## Access Compliance Report Public Rights-of-Way (Curb Ramps)

Intersection ID: N/A
 Main Street: ASCENSION\_WY
 Cross Street: HORACE\_ST
 Location:
 W

ADA ID: E47FBA16E6BC
 Ramp Type: Perp
 Initial Pass/Fail: Fail
 Overall Compliance: No
 Severity Score: 12.5

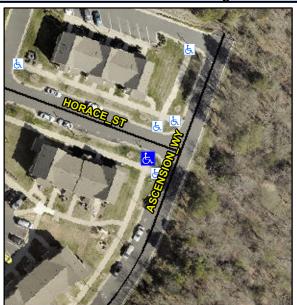
r.	Possible Solutions:
-	Remove & Replace Entire Ramp.
200	
200	
	Surveyor Notes:
V.	N/A
100	
S. L.	
1	PROW/ADA:
1000	R304.2.2
3	
雄

Compliance Description		Data	Comp	liance	Description	Data
N/A	Ramp Length (in)	72.0	No	Ram	Slope (%)	9.1
Yes	Ramp Width (in)	70.0	Yes	Ram	XSlope (%)	1.4
N/A	Flare Type LT	N/A	N/A	Flare	Type RT	N/A
N/A	Flare Slope LT (%)	N/A	N/A	Flare	Slope RT (%)	N/A
N/A	Flare Traversable LT?	N/A	N/A	Flare	Traversable RT?	N/A
N/A	Landing Length (in)	N/A	N/A	DWS	Provided?	N/A
N/A	Landing Width (in)	N/A	N/A	DWS	Contrast?	N/A
N/A	Landing Slope (%)	N/A	N/A	DWS	Length (in)	N/A
N/A	Landing X Slope (%)	N/A	N/A	DWS	Full Width?	N/A
N/A	Landing Curb? (Y/N)	N/A	N/A	DWS	Offset (in)	N/A
N/A	Shared Landing?	N/A				
N/A	Gutter Ponding?	N/A	N/A	Gutte	r Slope (%)	N/A
N/A	Gutter Lip Ht (in)	N/A	N/A	Gutte	er X Slope (%)	N/A
N/A	Painted X Walk1?	No	N/A	Paint	ed X Walk2?	N/A
	X Walk 1 Direction	To NE		X Wa	lk 2 Direction	N/A
N/A	X Walk 1 Width (in)	N/A	N/A	X Wa	lk 2 Width (in)	N/A
	X Walk 1 Slope (%)	1.9		X Wa	lk 2 Slope (%)	N/A
	X Walk 1 X Slope (%)	1.5		X Wa	lk 2 X Slope (%)	N/A
